NL-13-1073

Joseph M. Farley Nuclear Plant
Response to Request for Additional Information Concerning the Deferral of
Inservice Inspection of Reactor Pressure Vessel Cold Leg Nozzle Dissimilar
Metal Weld – Questions 2, 4, and 6

**SNC Response to Request for Additional Information – Questions 2, 4 and 6 (Non-
Proprietary)**

Figure 1

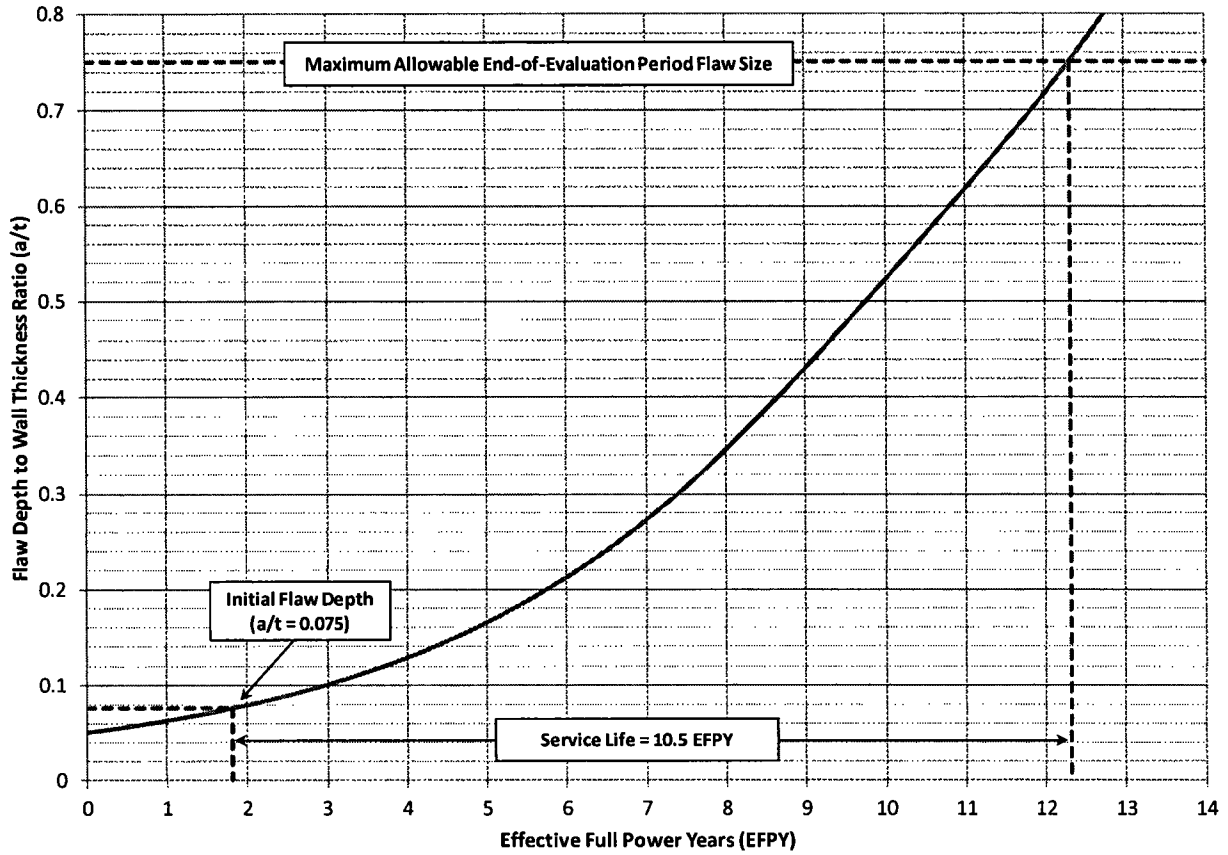
Provide a flaw evaluation for axial flaw growth for 10-years. Provide the bounding residual hoop stress profiles used in the analysis.

The input required for the axial crack growth analysis is basically the information necessary to calculate the crack tip stress intensity factor (K_I), which depends on the geometry of the crack, its surrounding structure and the applied loadings. The loadings considered are those due to normal operating steady state pressure as well as the welding residual stress. The welding residual stresses used in the PWSCC crack growth analysis are obtained from the finite element residual stress analysis (Reference 1) for the Joseph M. Farley Nuclear Plant (FNP), Units 1 and 2, plant specific reactor vessel inlet nozzle DM weld configurations (References 2 through 5). The finite element residual stress analysis was performed in accordance with the guidance given in MRP-287 (Reference 6) and MRP-317 (Reference 7). A two-dimensional axisymmetric model of the inlet nozzle dissimilar metal weld region is used in the finite element analysis which includes a portion of the low alloy steel nozzle, the stainless steel safe end, a portion of the stainless steel piping, the DM weld attaching the nozzle to the safe end followed by the stainless steel weld attaching the safe end to the piping. The distance between the centerlines of the DM weld and stainless steel weld is 4.7 inches which bounds the as-built safe end lengths of both FNP Units 1 and 2. The residual stress analysis includes the effects of a full circumferential 360° inside surface weld repair with a repair depth of 50% through the original dissimilar metal weld thickness. The bounding residual hoop stress profile used in the PWSCC crack growth analysis is shown in Figure 1.

Bounding Residual Hoop Stress Profile used in the PWSCC crack growth analysis
